CPSES-200701076
Log # TXX-07106

SUBJECT: COMANCHE PEAK STEAM ELECTRIC STATION
DOCKET NOS. 50-445 AND 50-446
LICENSE AMENDMENT REQUEST (LAR) 07-004, REVISION TO THE OPERATING
LICENSE AND TECHNICAL SPECIFICATION 1.0, "USE AND APPLICATION" AND
3.7.17, "SPENT FUEL ASSEMBLY STORAGE" TO REVISE RATED THERMAL POWER
FROM 3458 MWt TO 3612 MWt -

Attachment 2 provides the marked-up page of the Unit 1 Operating License to reflect the proposed change. Attachment 3 provides the marked-up page of the Unit 2 Operating License to reflect the proposed change. Attachment 4 provides the affected Technical Specification (TS) pages marked-up to reflect the proposed change. Attachment 5 provides retyped Unit 1 Operating License page which incorporates the requested change. Attachment 6 provides retyped Unit 2 Operating License page which incorporates the requested change. Attachment 7 provides the retyped Technical Specification pages which incorporate the requested changes. Attachment 8 provides the Environmental Assessment for the proposed License Amendment Request. Attachment 9 provides the proposed Technical Specification Bases pages marked-up to reflect the changes to the Technical Specifications (

FIGURE 3.7.17-1
Fuel Assembly Burnup vs. U-235 Enrichments vs. Decay Time Limits
For a 4 out of 4 Storage Configuration in Region II Racks

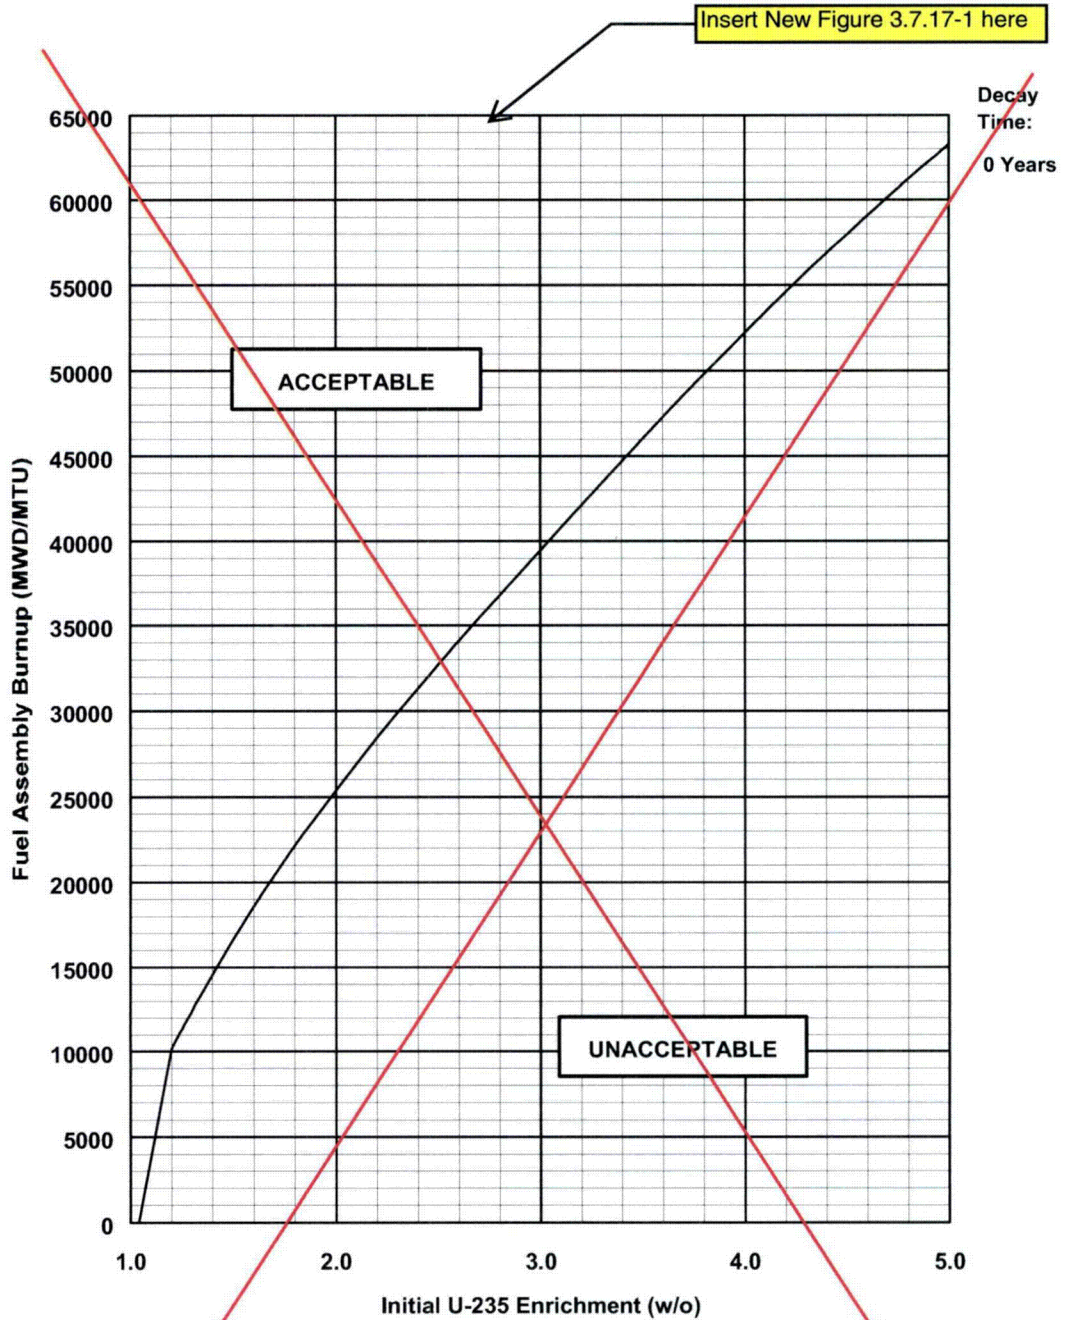
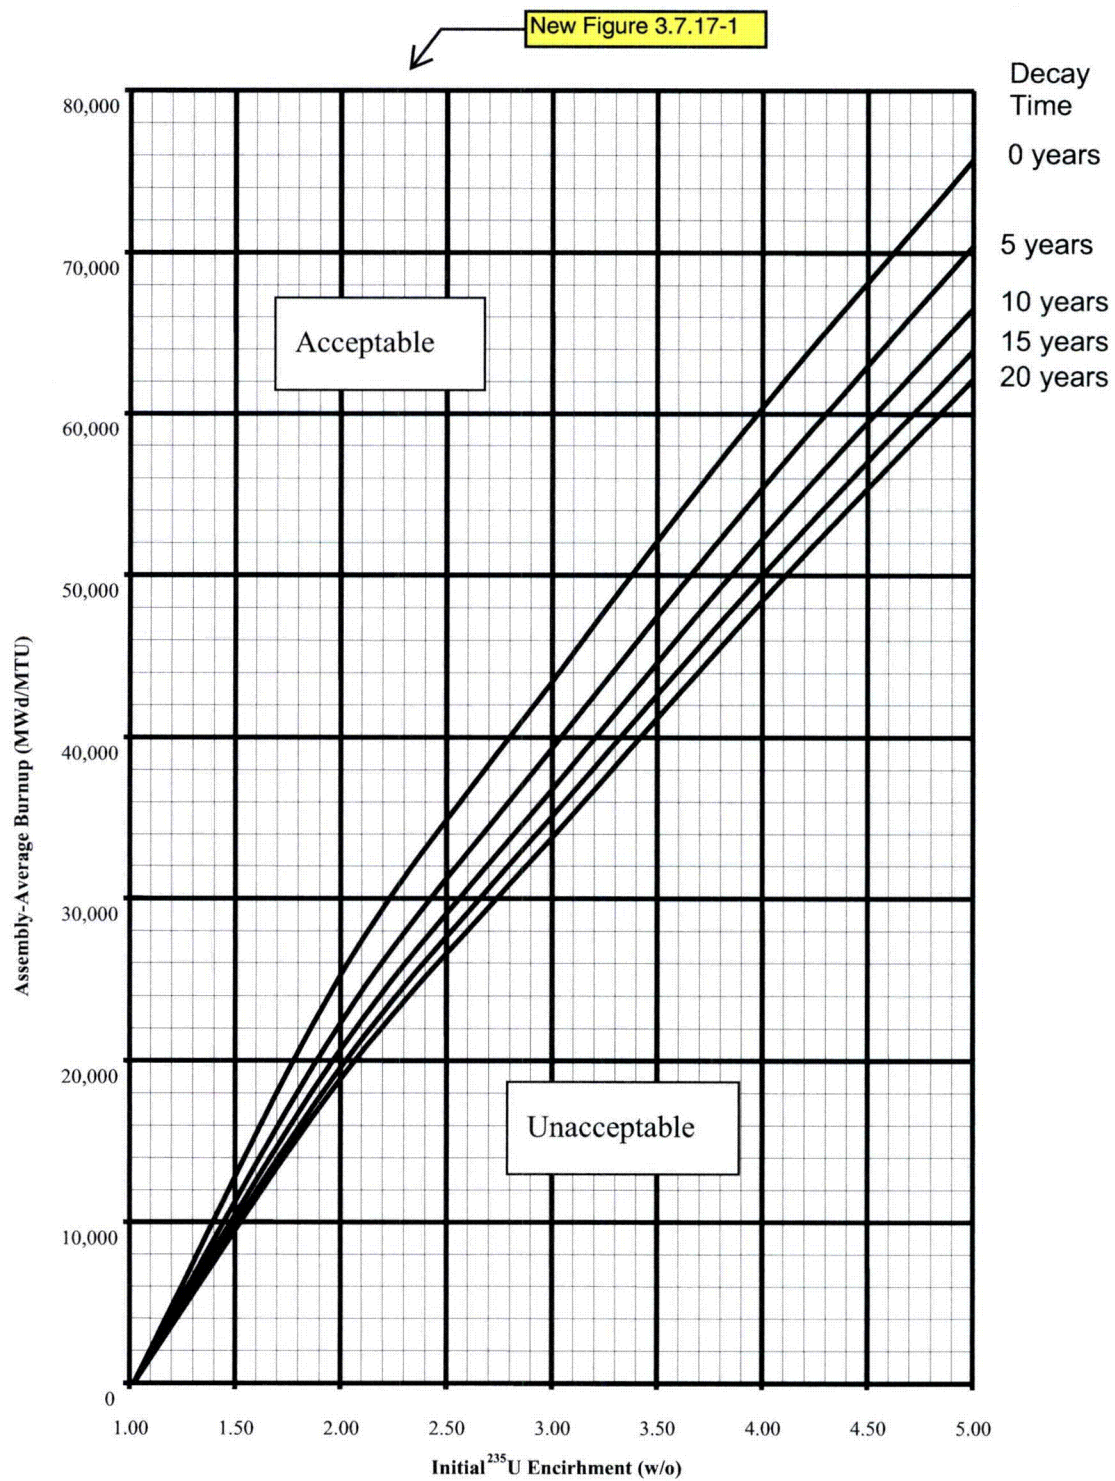
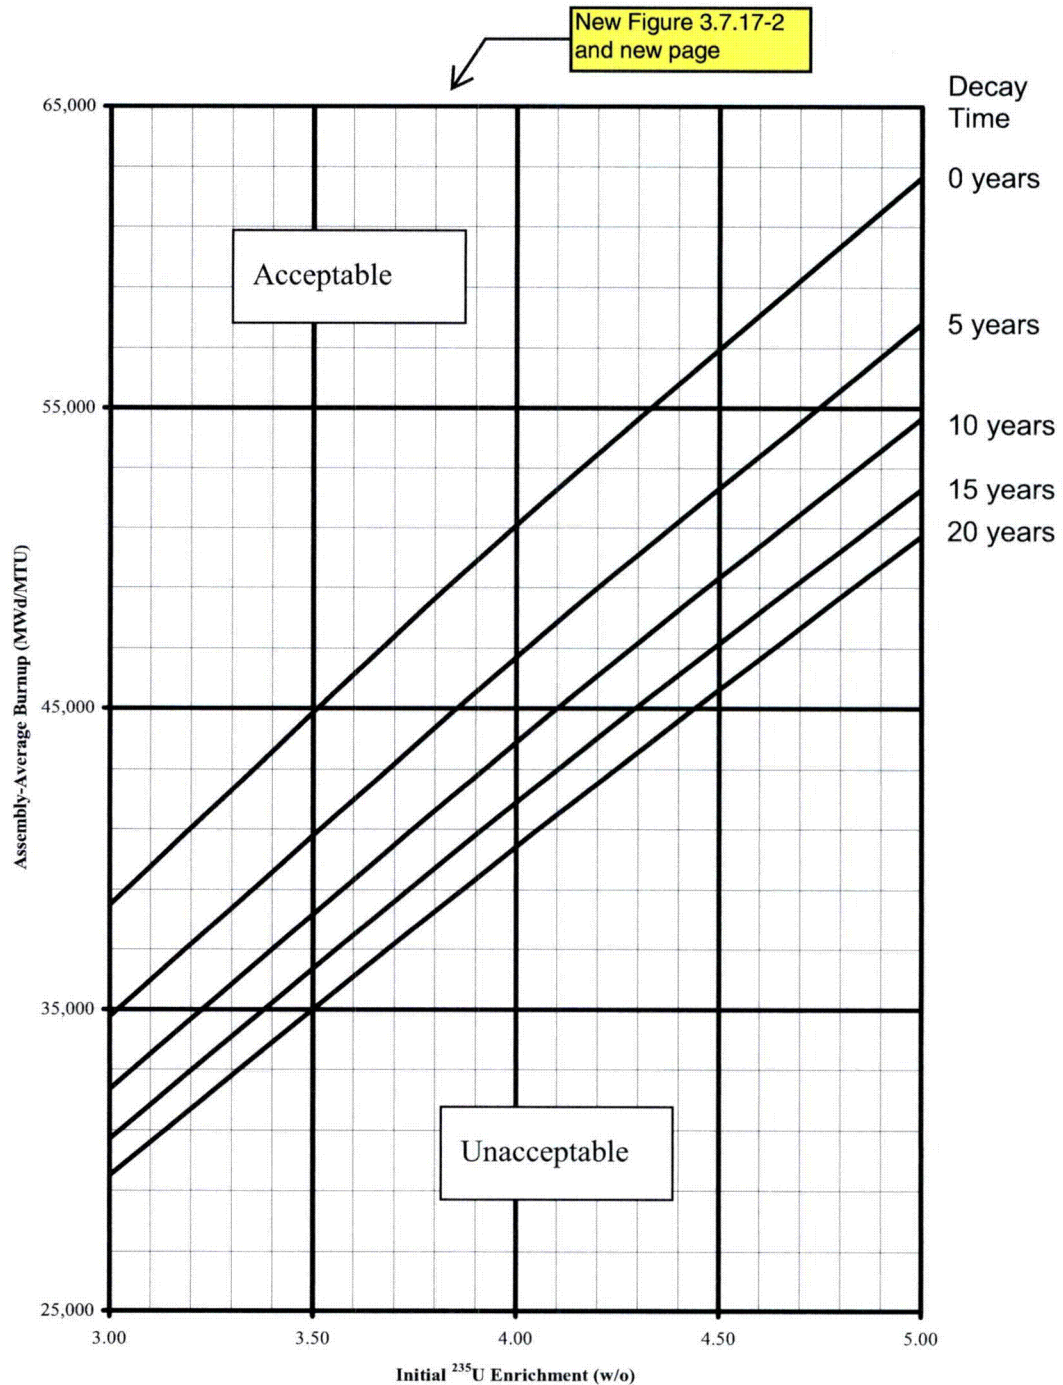
The combination of initial enrichment, burnup and decay time of each spent fuel assembly stored in Region II racks shall be within either (1) the "acceptable" domain of ~~Figure 3.7.17-1~~ in a 4 out of 4 configuration, (2) the "acceptable" domain of ~~Figure 3.7.17-2~~ in a 3 out of 4 configuration, (3) the "acceptable" domain of ~~Figure 3.7.17-3~~ in a 2 out of 4 configuration, or (4) shall be stored in a 1 out of 4 configuration. The acceptable storage configurations are shown in ~~Figure 3.7.17-4~~.

- A Region II (4/4), new or partially spent fuel assemblies in the "acceptable" domain of Figure ~~3.7.17-1~~. ← **3.7.17-1 or 3.7.17-2.**
- B Region II (3/4), new or partially spent fuel assemblies in the "acceptable" domain of Figure ~~3.7.17-2~~. ← **3.7.17-3 or 3.7.17-4.**
- C Region II (2/4), new or partially spent fuel assemblies in the "acceptable" domain of Figure ~~3.7.17-3~~. ← **3.7.17-5.**
- D Region II (1/4), new or partially spent fuel assemblies which are stored in an expanded checkerboard (1 out of 4).

Figure 3.7.17-1
Minimum Required Fuel Assembly Burnup versus Initial ²³⁵U Enrichment for the
"4-out-of-4" Storage Configuration

Figure 3.7.17-2
Minimum Required Fuel Assembly Burnup versus Initial ²³⁵U Enrichment for the
"4-out-of-4 with Axial Blankets" Storage Configuration

Figure 3.7.17-3
Minimum Burnup vs. Initial U-235 Enrichment
For a 2 out of 4 Storage Configuration in Region II Racks

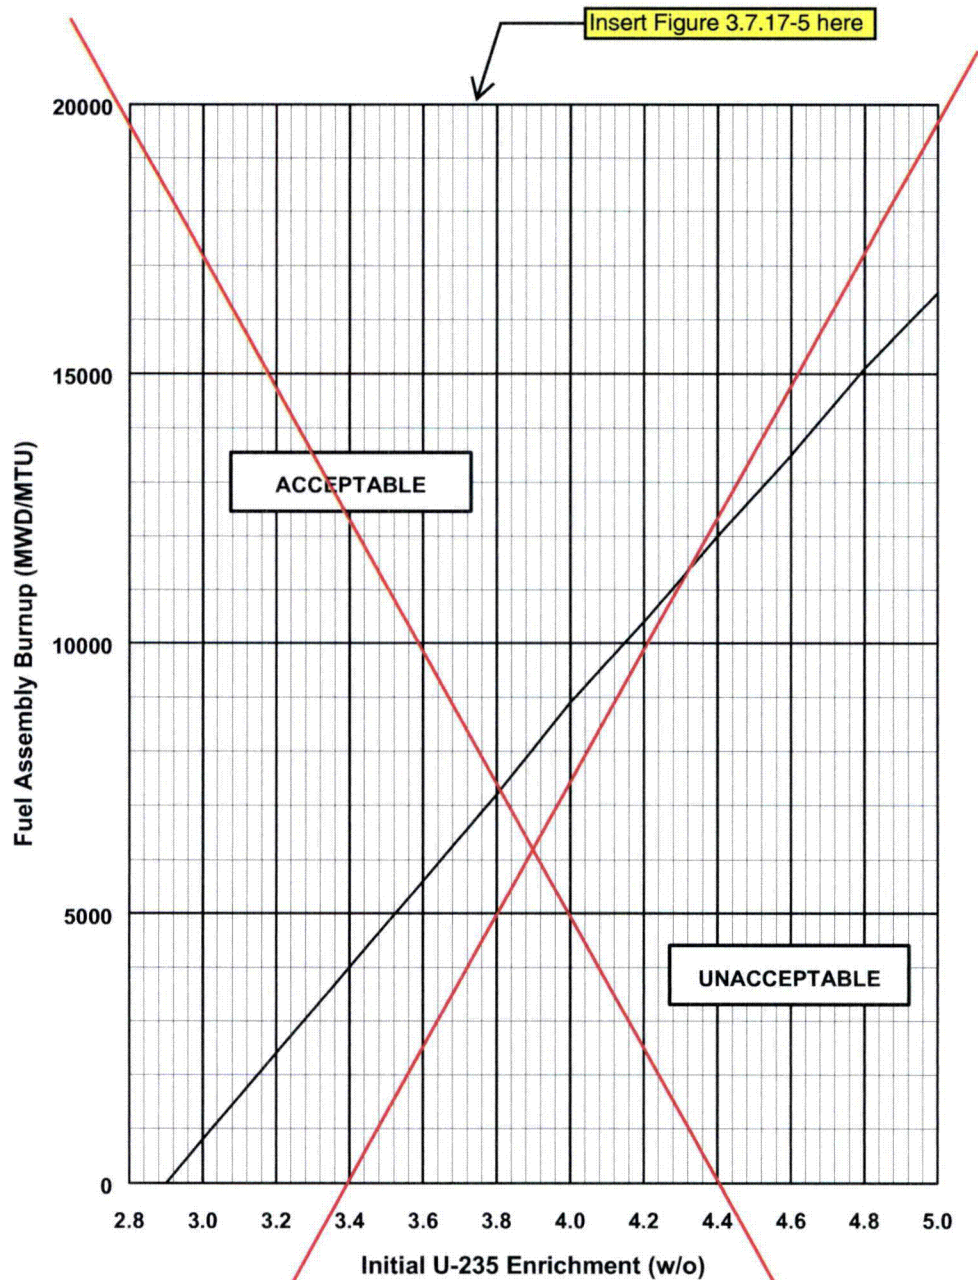
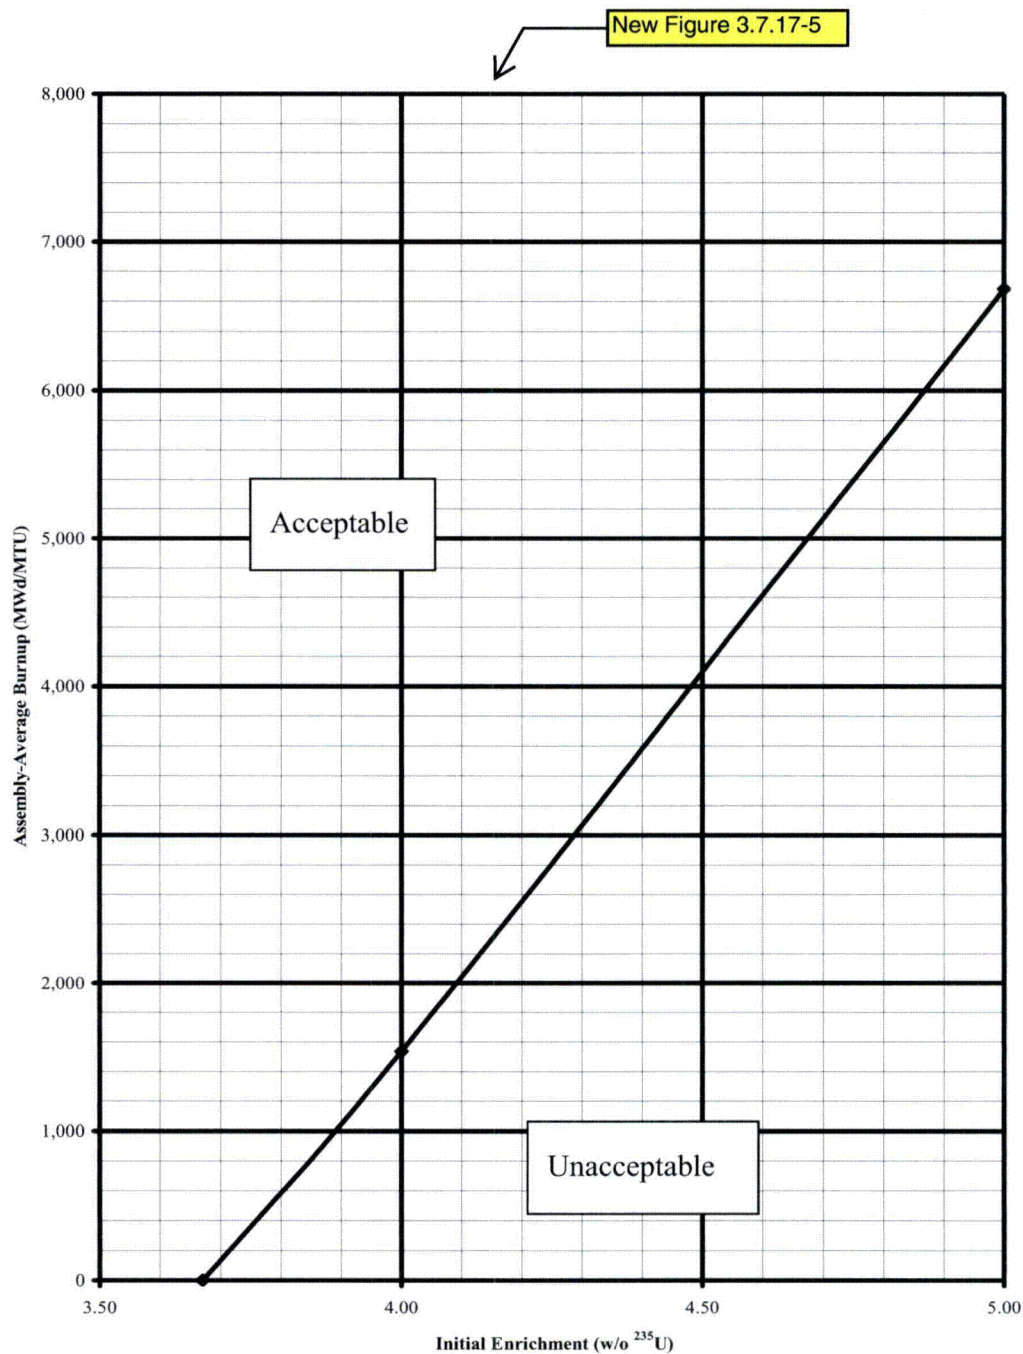
All possible 2 by 2 matrices containing Region II rack cells shall comply with at least one of the following. (1) within the "acceptable" domain of ~~Figure 3.7.17-1~~ in a 4 out of 4 configuration, (2) within the "acceptable" domain of ~~Figure 3.7.17-2~~ in a 3 out of 4 configuration, (3) within the "acceptable" domain of ~~Figure 3.7.17-3~~ in a 2 out of 4 configuration, or (4) a 1 out of 4 configuration. ← **Figure 3.7.17-5**

Figure 3.7.17-5
Minimum Required Fuel Assembly Burnup versus Initial ²³⁵U Enrichment for the
"2-out-of-4" Storage Configuration
